**VOGTLE ELECTRIC GENERATING PLANT
REQUEST TO REVISE TECHNICAL SPECIFICATIONS
PRESSURIZER SAFETY VALVE SETPOINT AND TOLERANCE
RESPONSE TO REQUEST FOR ADDITIONAL INFORMATION**

VOGTLE
ELECTRIC GENERATING
PLANT
UNIT 1 AND UNIT 2

INADVERTENT OPERATION OF ECCS DURING POWER
OPERATION

FIGURE 15.5.1-2

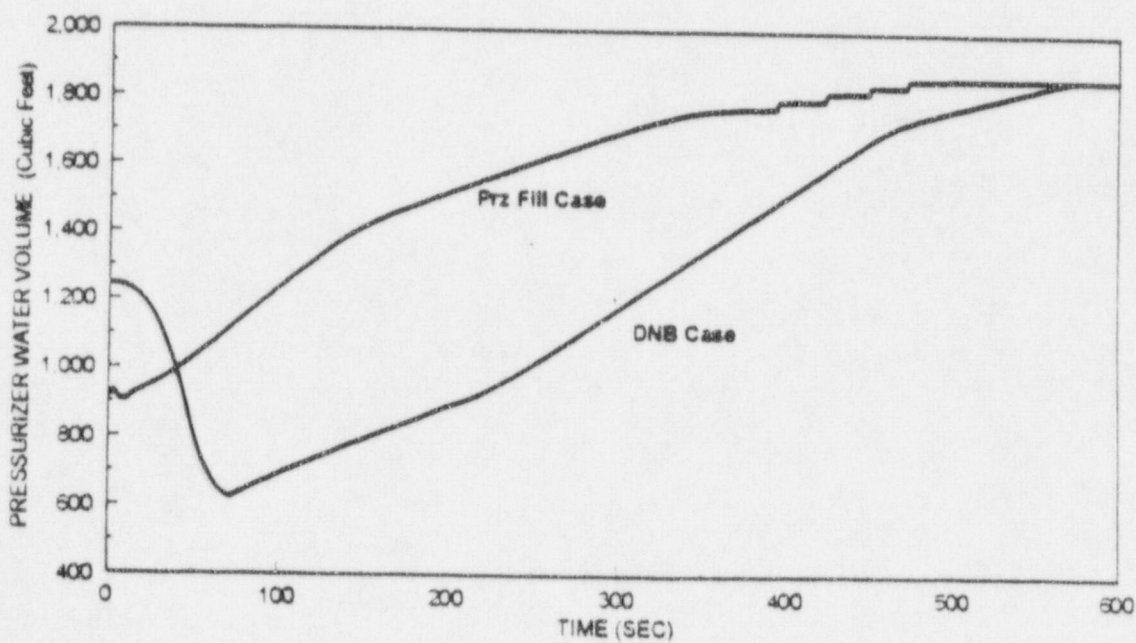
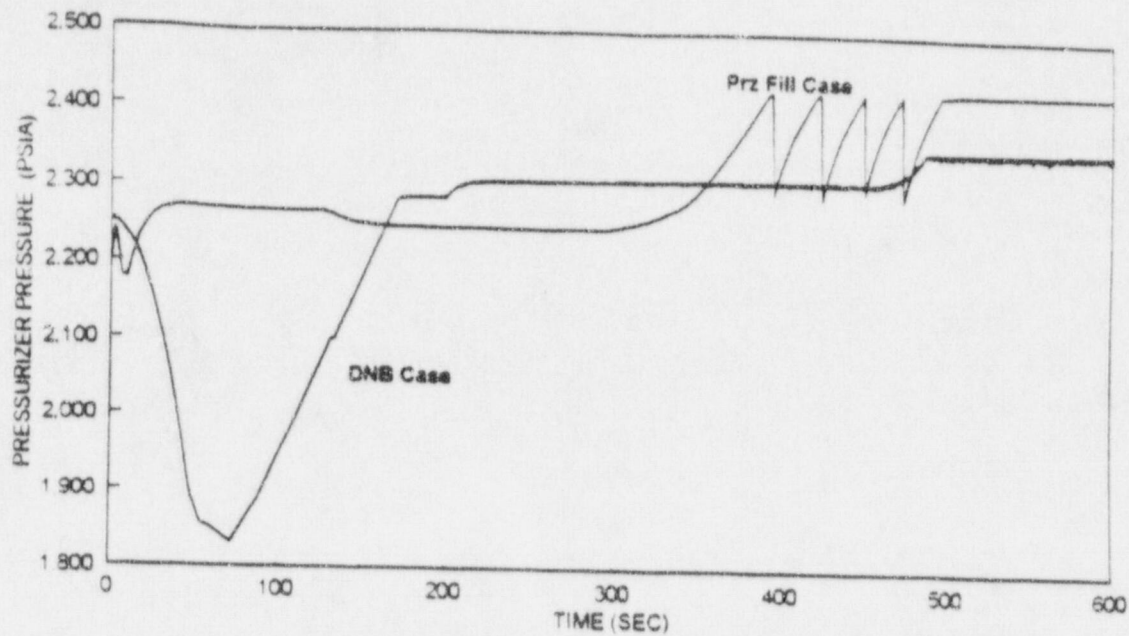
"Provide transient curves of the RCS pressure and pressurizer level."

The desired curves are provided as an attachment to this letter.
